Subject: Byron Station Units 1 and 2  
Braidwood Station Units 1 and 2  
Supplement to Application for Amendment to  
Facility Operating Licenses  
NPF-37, NPF-66, NPF-72 and NPF-77,  
Appendix A, Technical Specifications  
NRC Docket No.s 50-454, 50-455,  
50-456 and 50-457

A teleconference with NRC staff on March 14, 1991 resulted in several questions including a request for additional engineering analysis. The attachment lists the questions and Edison's responses.

Response to NRC of teleconference of March 14, 1991.

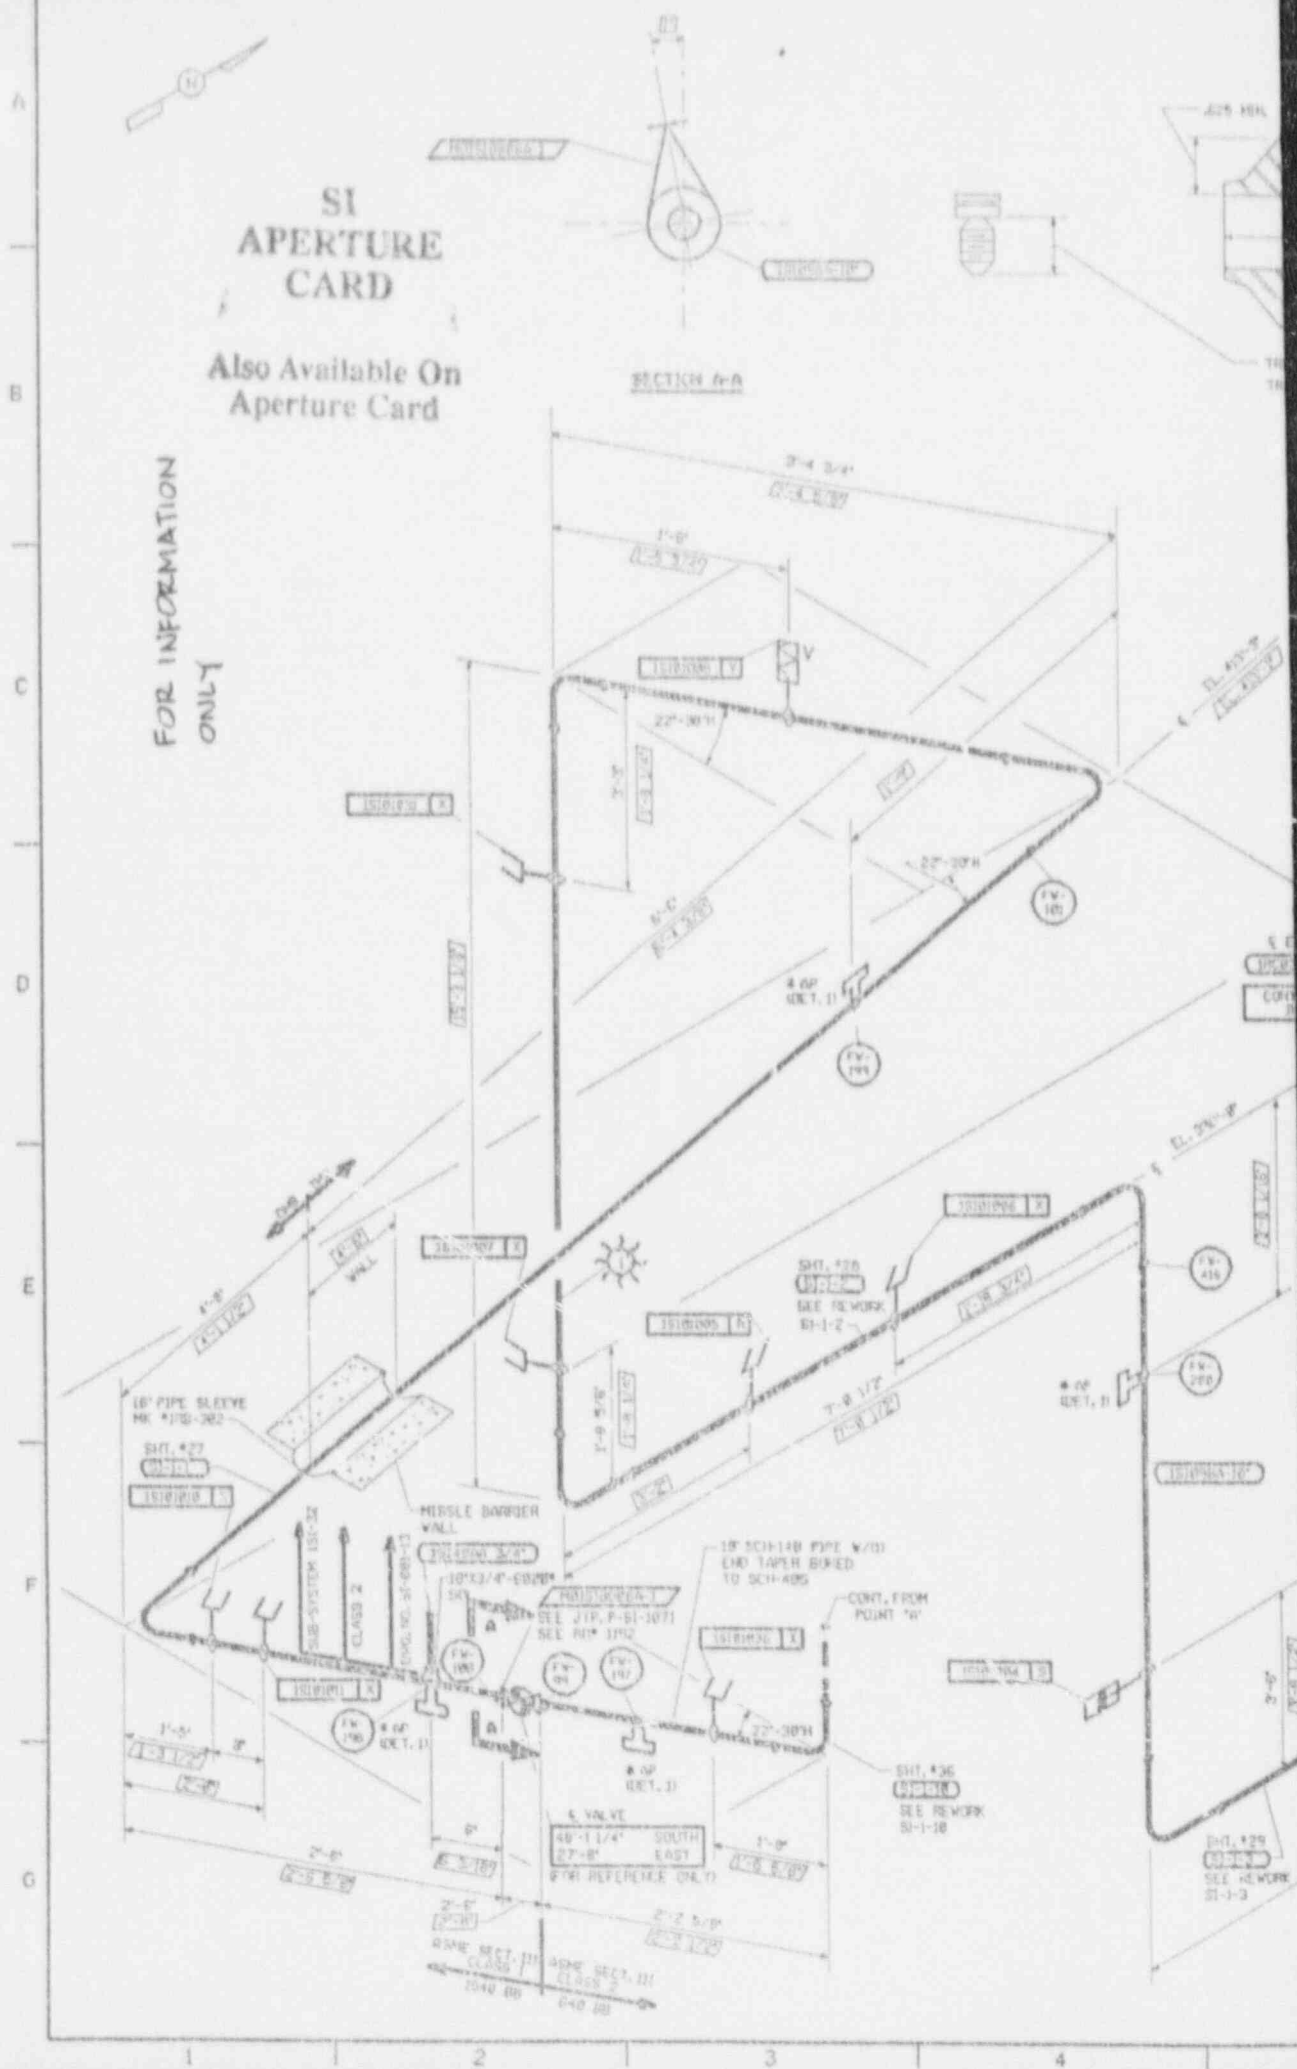
Provide calculations that show the minimum flow rate to sweep air from the residual heat removal piping and describe how often this is done. Describe the methods used to sweep air from the RH system high points.

The minimum flow velocity required to sweep an air bubble out of a piping system may be determined by using a criteria where the pipe "runs full" at all times. This criteria is that the Froude number is equal to 1 as discussed in Section 3. This results in a filling velocity greater than or equal to 4.3 fps or 489 gpm (see Section 5) for the piping inside containment in the Emergency Core Cooling System (ECCS) at Commonwealth Edison's Braidwood Power Station.

Since the pump rated flow is 4500 gpm (Ref. 4.3), any air bubble in the upper flow split path ( $Q = 2225$  gpm) will be purged out of the system for just about any case of pump start-up.
